City of  
Richmond

## Report to Development Permit Panel

**File:** DP 11-564405

**Re:** **Application by Dava Development Ltd. for a General Compliance Ruling at Portions of 10111, 10197 & 10199 River Drive (formerly Portions of 10111 & 10199 River Drive)**

Plan 24a Sept 15, 2016  
DP 11-564405

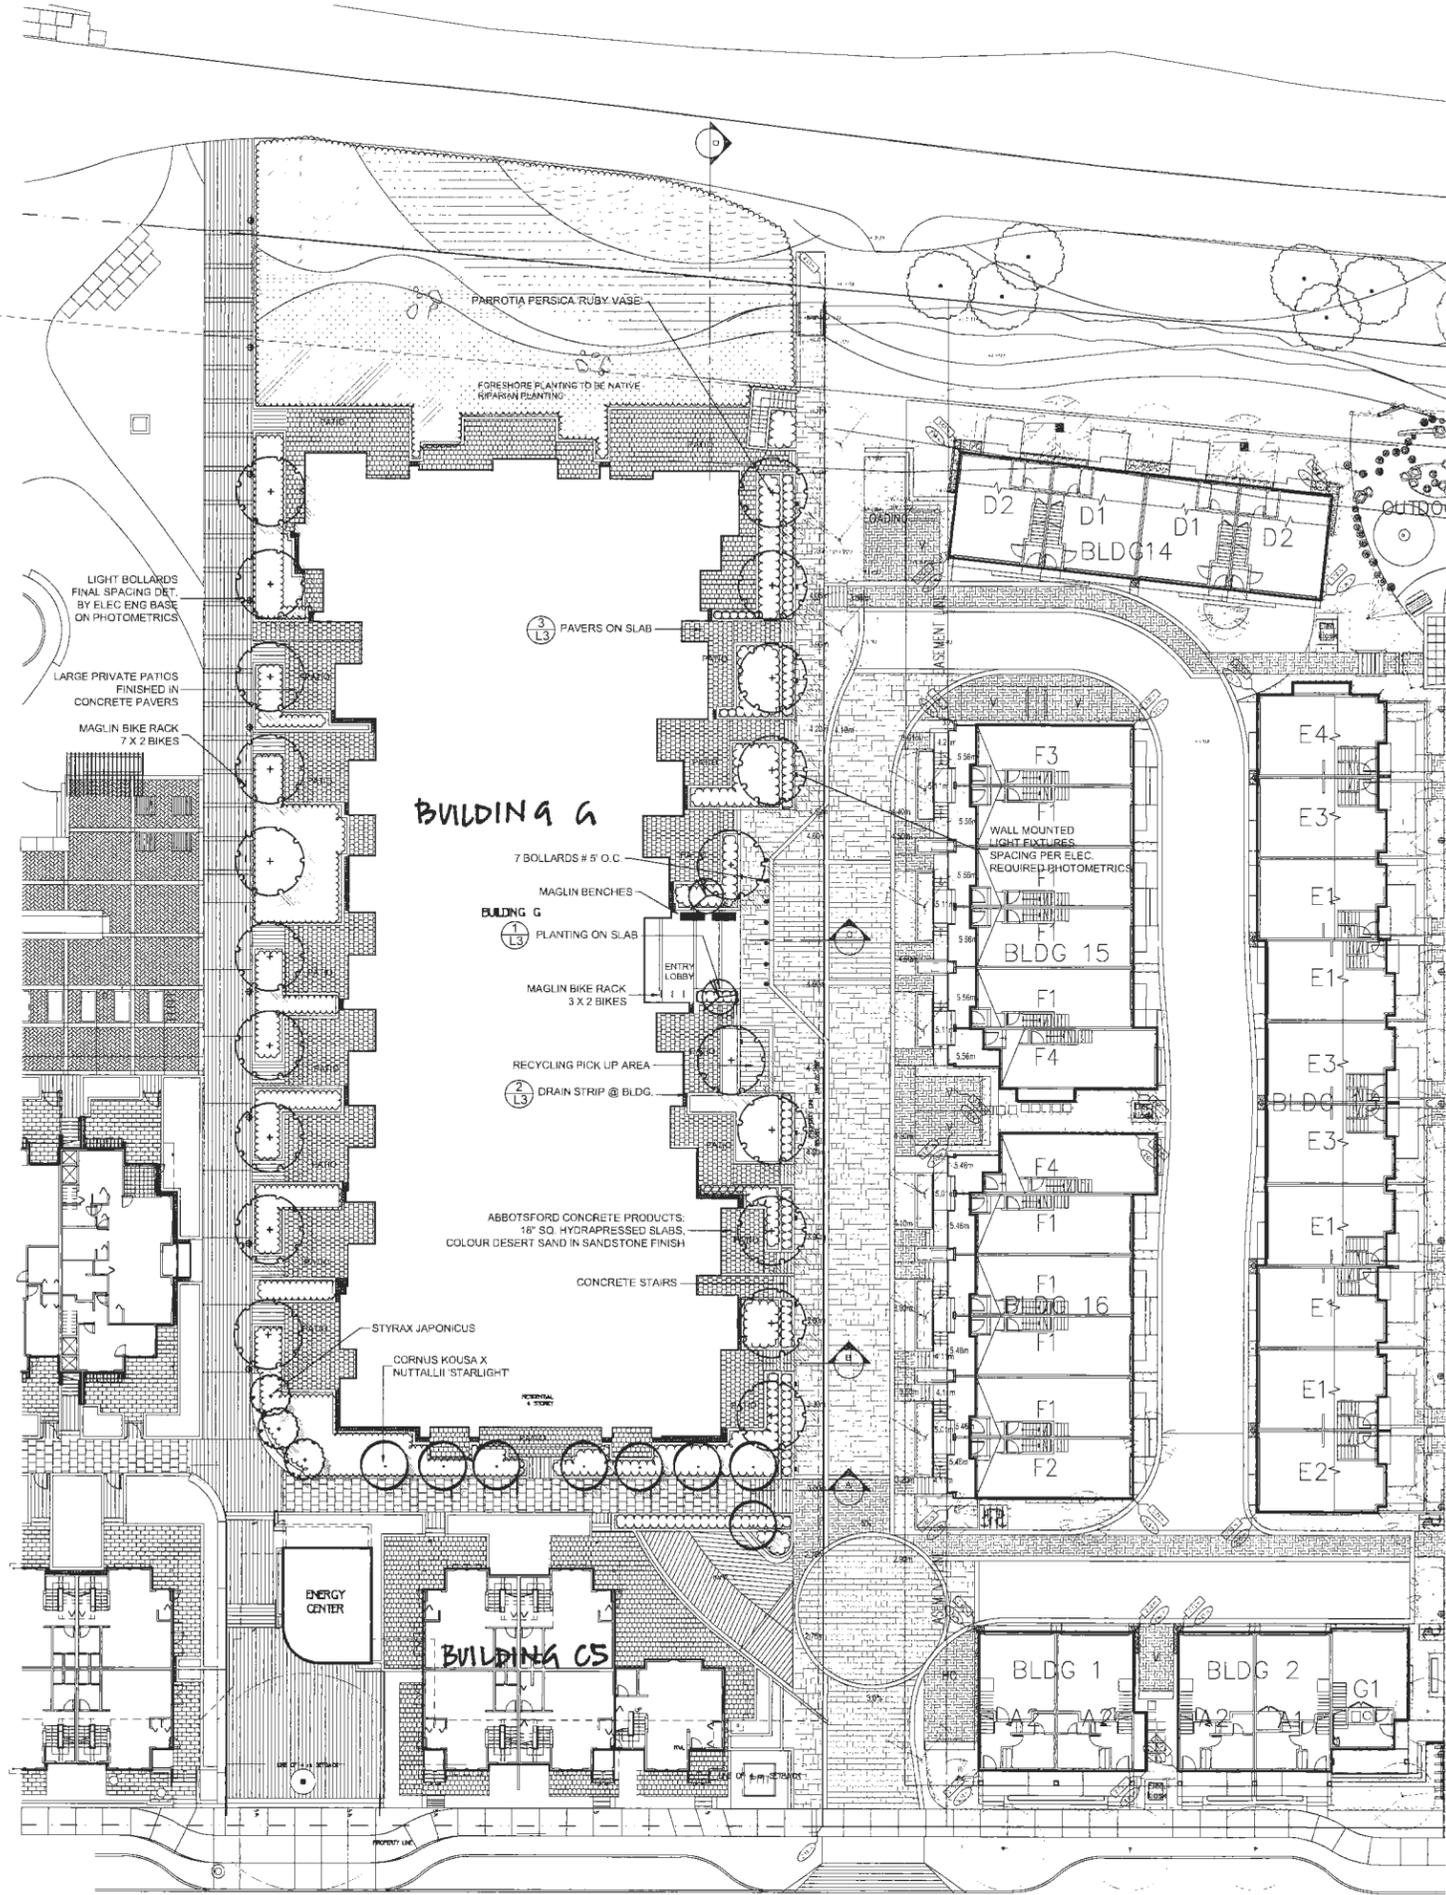
Supplements Plan 24 with layout, trees and materials at Building G and drive aisle

**L2**

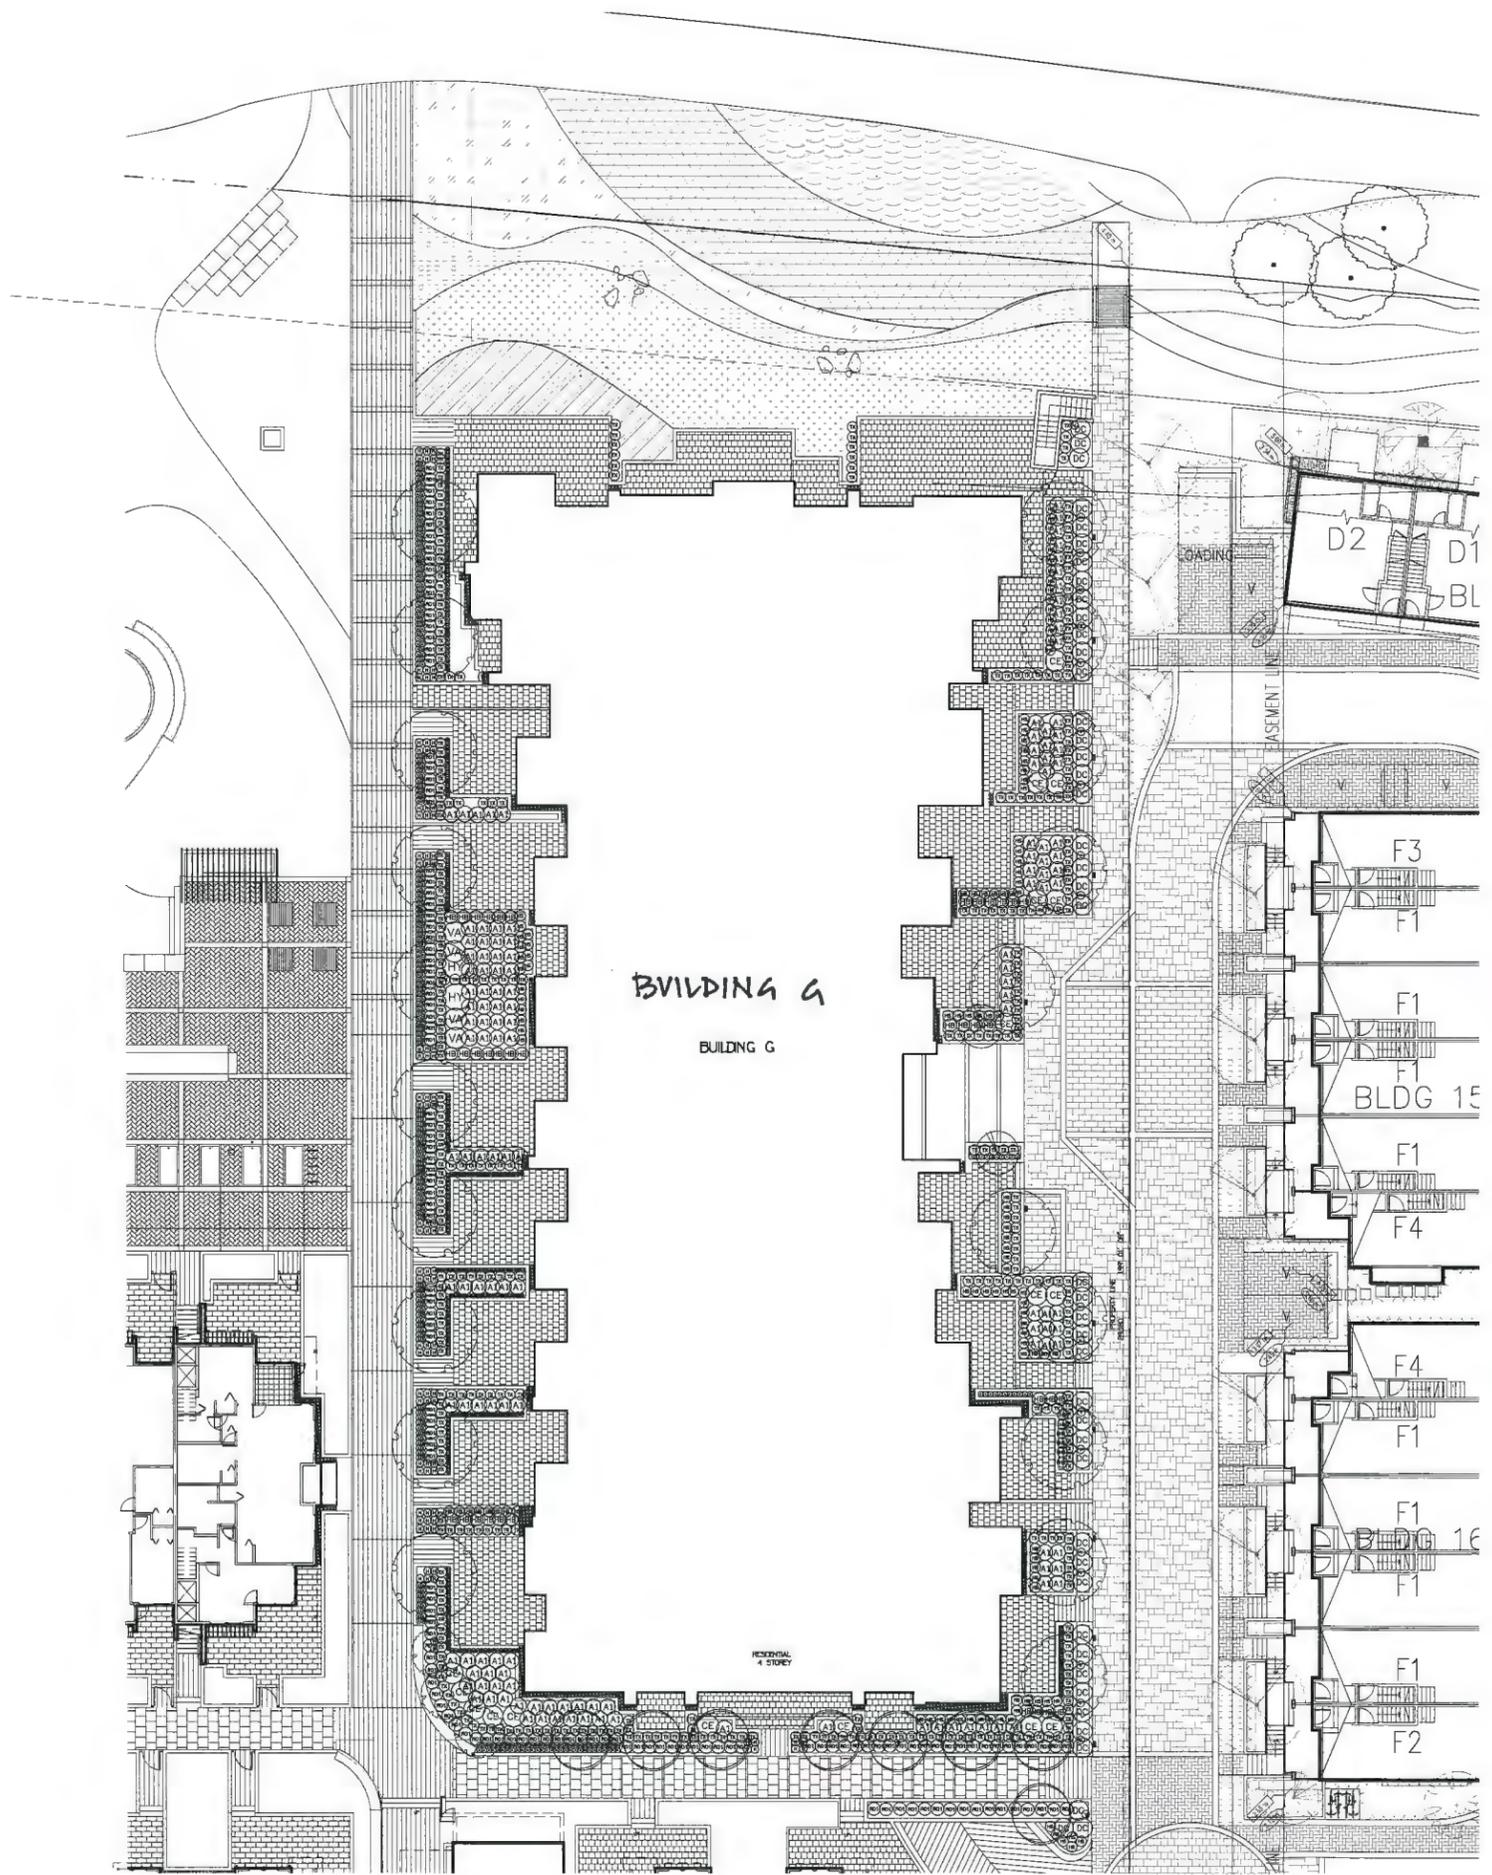
Supplements Plan 24 with shrub layout at Building G

Plan 24c Sept 15, 2016  
DP 11-564405

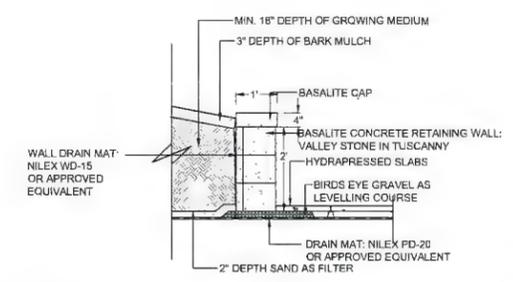
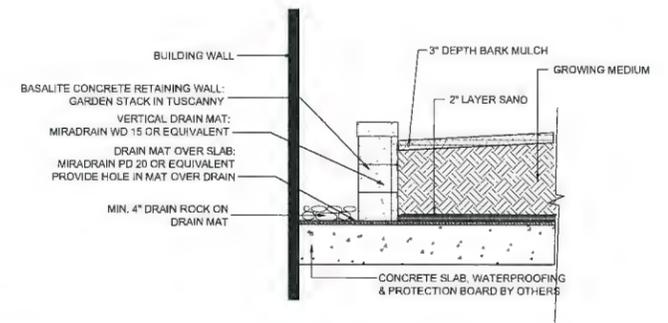
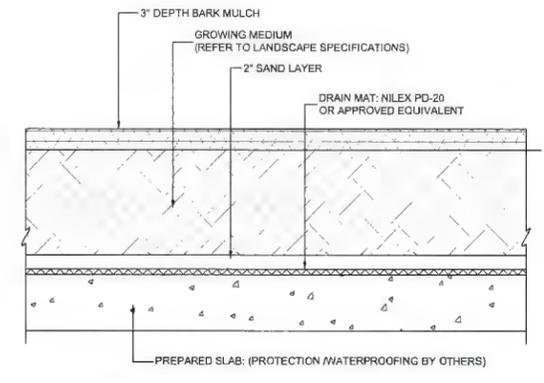
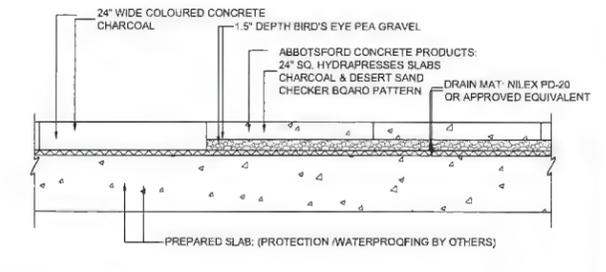
Supplements Plan 24 with details at Building G

Plan 24d Sept 15, 2016  
DP 11-564405

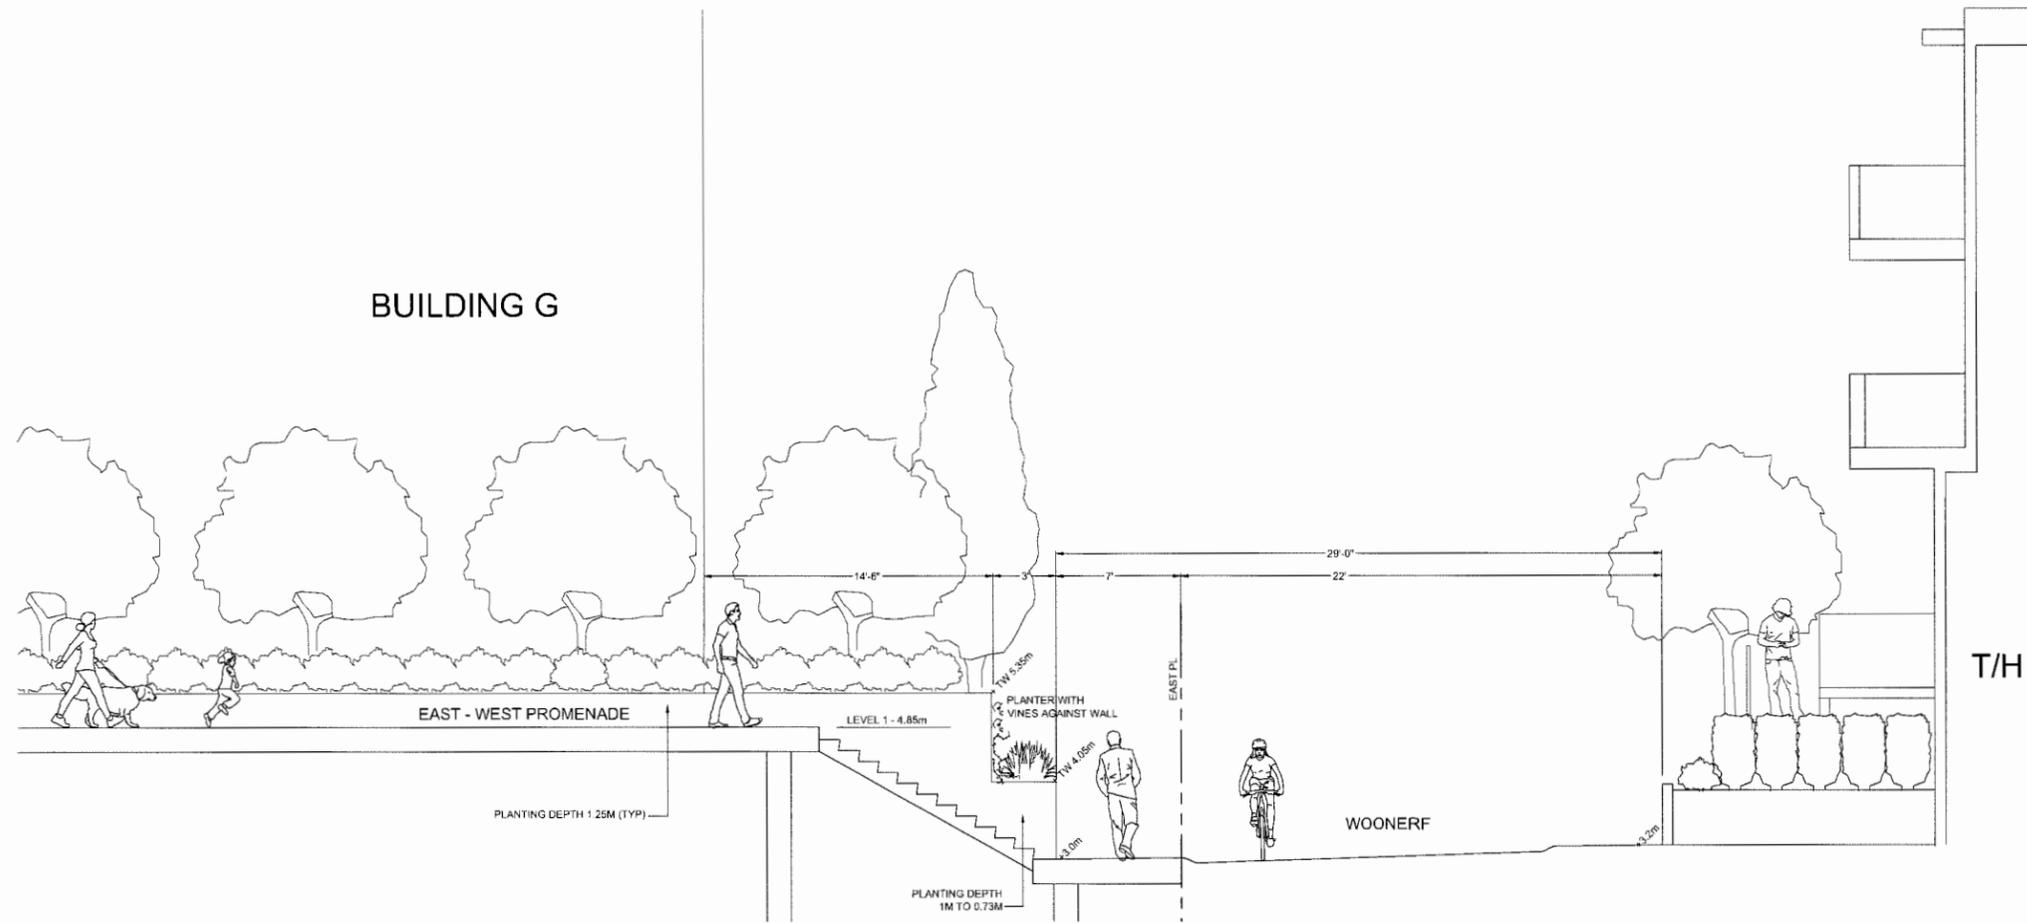
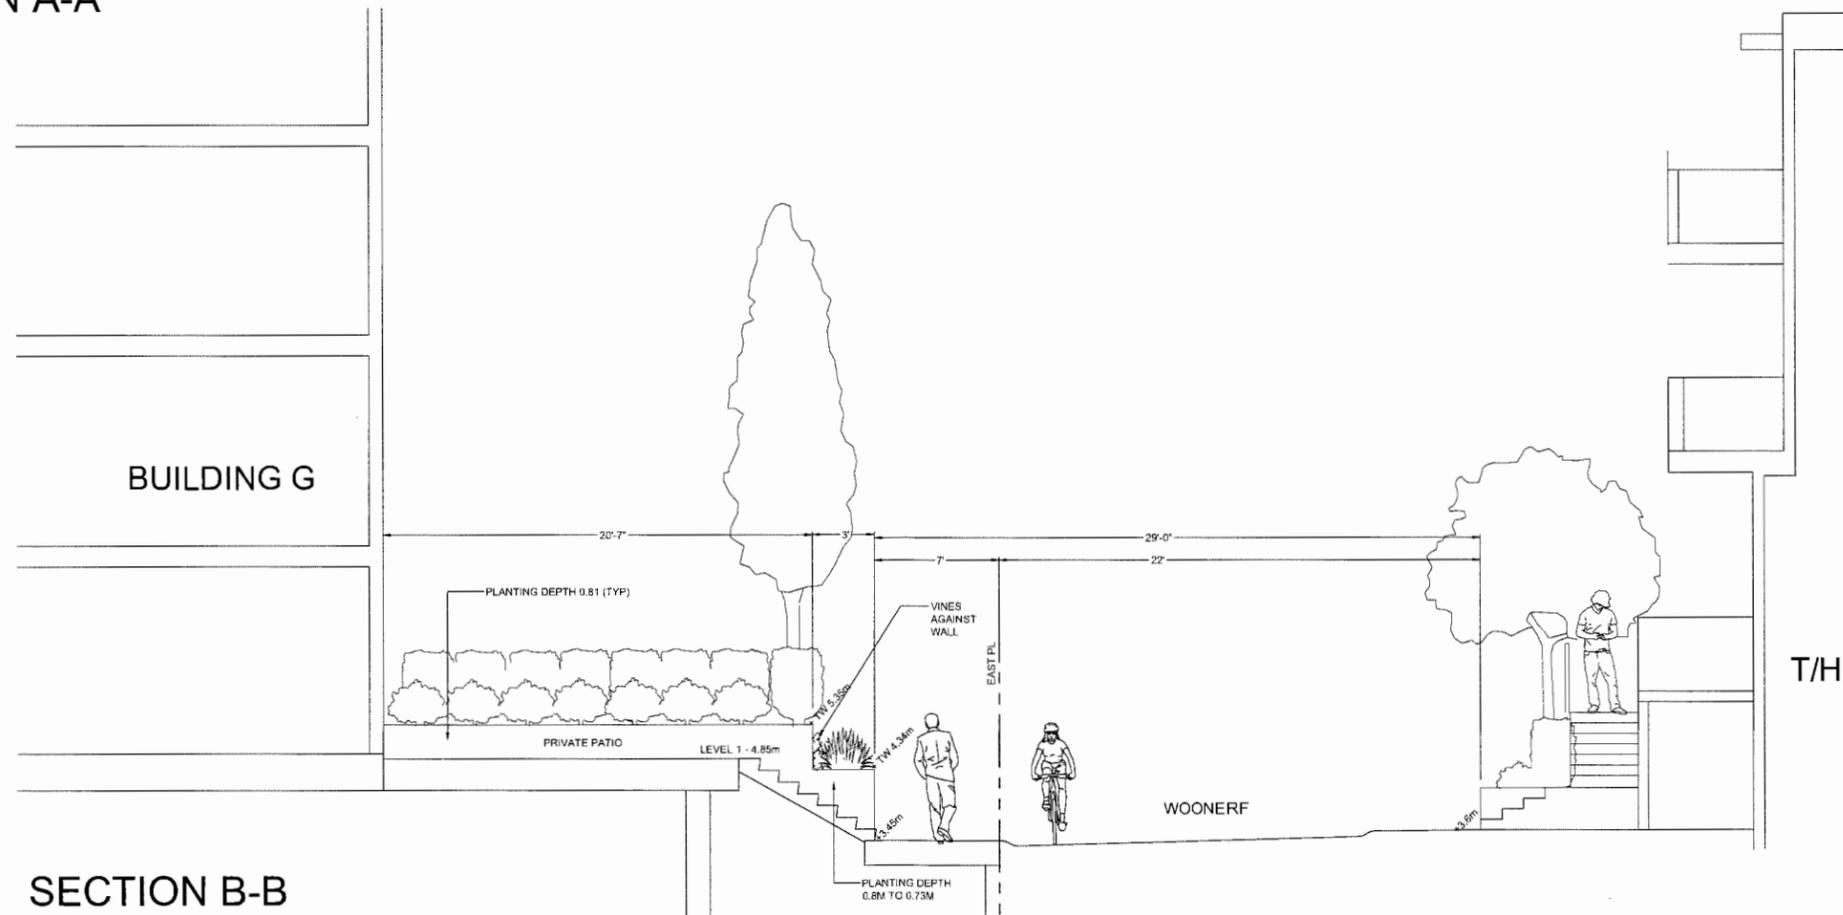
Supplements Plan 24 with sections at Building G
